SUBMITTAL TRANSMITTAL

WCM Submittal No: 11314-001.B

PROJECT: Harold Thompson Regional WRF
Birdsall Rd.
Fountain, CO 80817
Job No. 2908

SUBJECT: Deviation submittal information for pump/skid

4X16 HDPL 100%
RECESSED IMPELLER PUMP
"C" FLOW CONFIGURATION
WITH SPECIAL 32" BASE

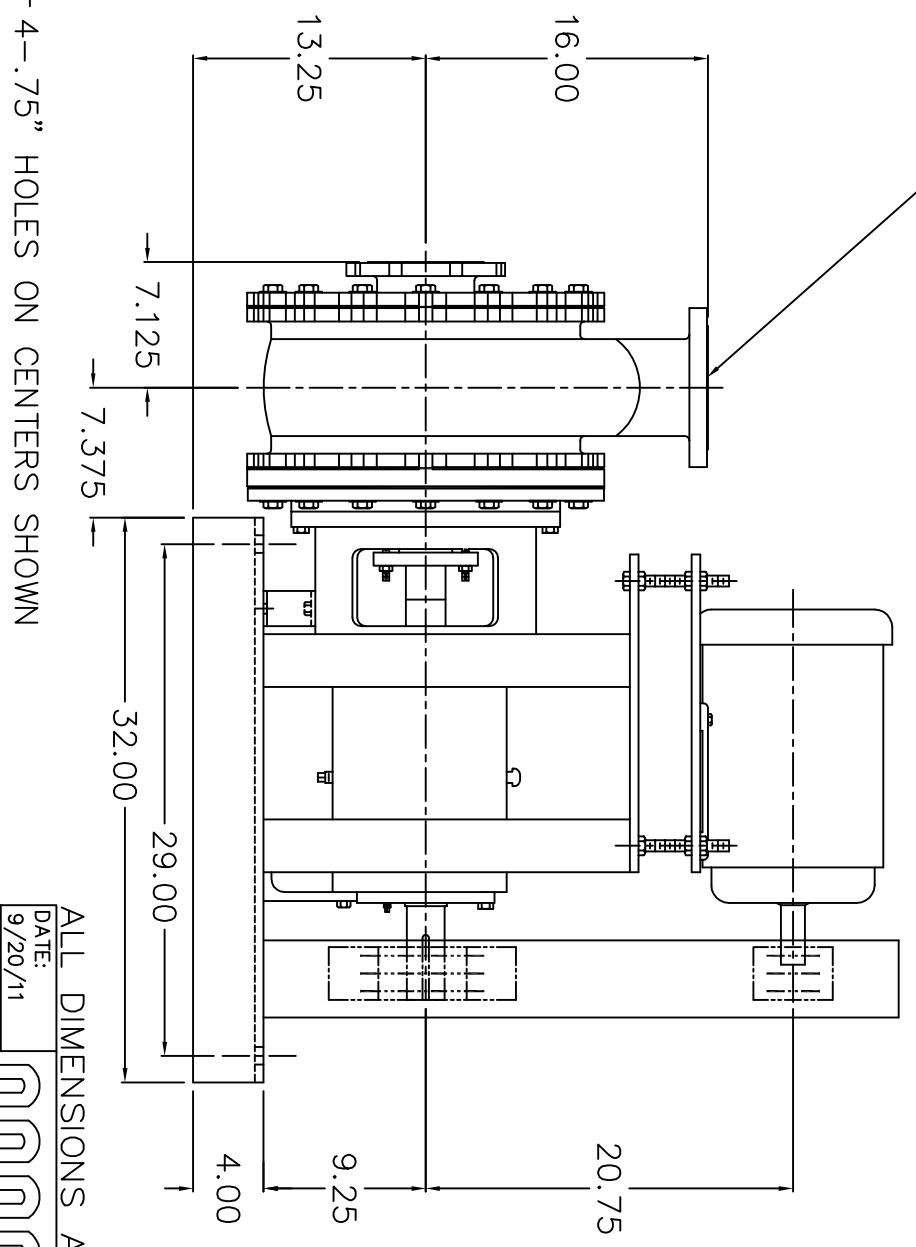
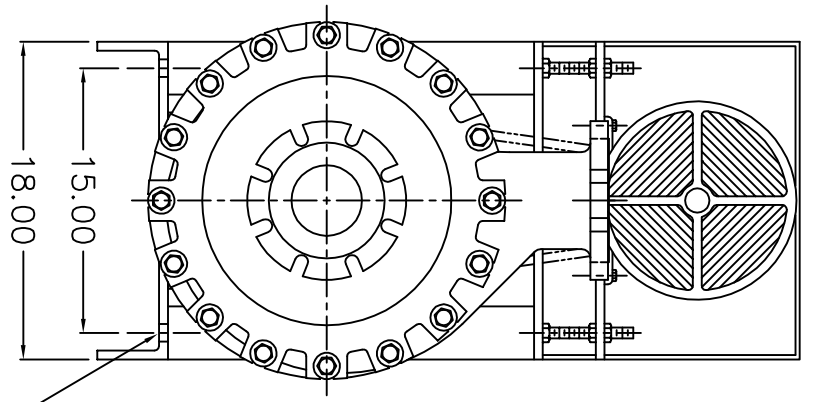
Deviations:

- Submitted pump/skid dimensions differ from the pump/skid layout shown in the drawings.
- Based on the Contract drawings the approximate length of the pump/skid is 40" from suction to belt guard. The submittal drawing shows a length of 46.5" from suction to end of skid. This would shorten the suction FLG x FLG spool piece to approximately 7". Additionally, we propose to change this spool to FLG x PE with a uniflg. This would allow easier removal of the spool in the future for maintenance. This would also shorten the FLG x FLG horizontal discharge spool piece.

- The Contract drawings show the pump discharge being offset from the pump 'housing' while the submittal drawing locates the discharge at the center of the pump 'housing'. We do not see an issue with arrangement. This will eliminate one 90 bend and add a short FLG x FLG spool before the plug valve, and modify the length of the two horizontal spool pieces that both pumps discharge into.

- The Contract drawings show the width of the pump concrete pedestal at 2'-10" while the submittal drawing shows the skid width at 1'-6". We can reduce the overall width of the pump concrete pedestal to 2'-0".
